## ***Interactive comment on “Improving measurements of SF<sub>6</sub> for the study of atmospheric transport and emissions” by B. D. Hall et al.***

Response to reviewer #1: AMTD doi:10.5194/amtd-4-4131-2011

**Fig. 1.** Figure 4 (revised): History of SF<sub>6</sub> precision (%) from all samples analyzed on the GC-ECD systems used for calibrations (color-coded by SF<sub>6</sub> mole fraction (ppt)). Upper plot shows three GC versions.

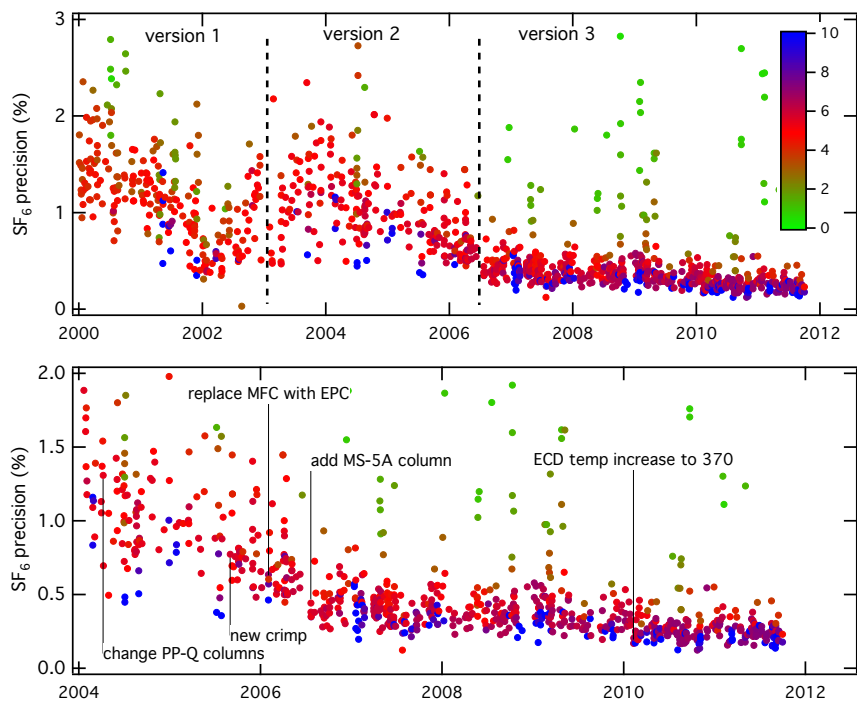
The reviewer notes that the change in SF<sub>6</sub> precision does not seem to be conclusively linked to the addition of the post-column, and could be the result of other factors.

We agree that this aspect of the paper was not adequately presented. We maintain

that addition of the post-column was a major factor, and have revised text and Figure 4 to support this argument.

1) We have modified Figure 4 to include all reference gases analyzed on the calibration instruments (color-coded by mole fraction) and added a second panel to expand the period 2004-2011. Here, we have noted changes to the instrument before and after the addition of the post-column.
